U S NAVY RESPONSE TO U S EPA REGION I COMMENTS TO DRAFT SAMPLING AND
ANALYSIS PLAN ETHYL BLENDING PLANT TANK FARM 1 TRANSMITTAL NS NEWPORT RI

11/02/2011
TETRA TECH NUS

Subject: Transmittal of Response to Comments, Draft Sampling and Analysis Plan
Ethyl Blending Plant, Tank Farm 1
Naval Station Newport, Newport RI

**NAVY RESPONSES TO
U.S. ENVIRONMENTAL PROTECTION AGENCY (EPA)
COMMENTS DATED AUGUST 16, 2011
ON THE DRAFT SAMPLING AND ANALYSIS PLAN (APRIL 2011)
FOR THE ETHYL BLENDING PLANT, TANK FARM 1 DATA GAPS ASSESSMENT
NAVAL STATION NEWPORT
NEWPORT, RHODE ISLAND**

PROPOSED TRANSFORMER VAULT SAMPLE LOCATIONS
 TANK FARM 1
 DATA GAPS ASSESSMENT
 NAVSTA NEWPORT
 PORTSMOUTH, RHODE ISLAND

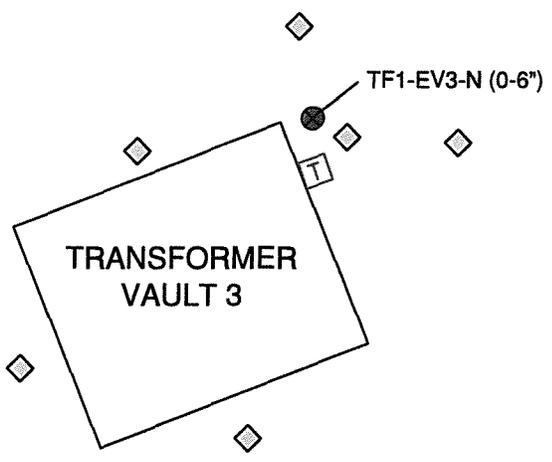
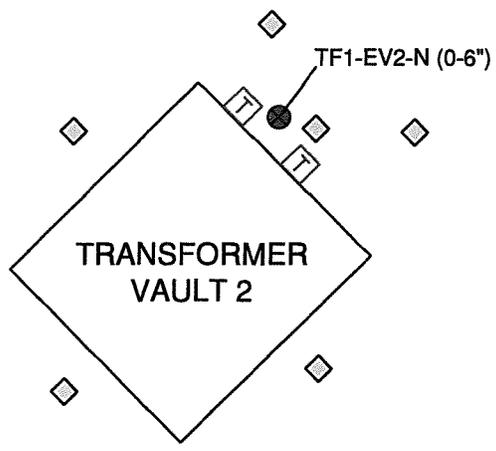
***Comment 2:** As was discussed during the conference call, the fact that the utilities are active does preclude their investigation for a release of a CERCLA contaminant. Tank Farm 1 is an inactive NPL site and therefore releases of contaminants there will be evaluated under CERCLA. The status of the location where the release occurs determines how the release is managed. Therefore, please include the investigation of the PCB releases in this SAP.*

Response: Navy agrees to conduct PCB sampling at the two transformer vault locations where PCBs have been previously detected during a 2010 Shaw sample event. Shaw sampling detected the presence of aroclor-1260 at transformer vaults 2 and 3 at concentrations of 24 mg/kg and 0.51 mg/kg, respectively.

Navy proposes to collect surface (0 to 1 foot) and subsurface (2 to 4 feet) soil samples in order to further characterize the extent of contamination. Soil sampling will be designed to confirm the PCBs in the two locations and to step out from each location in two horizontal directions and in the vertical (see attached figure). New soil boring locations will include one boring adjacent to the old location, and two borings 10 to 15 feet from the old locations with detections of PCBs. The sampling program has also been designed to determine if PCBs are present in subsurface soils by collecting subsurface soil samples from each location at the 2 to 4 foot below ground surface interval. Attached to this response to comment document is a proposed sample location map for transformer vaults 2 and 3 at Tank Farm 1.
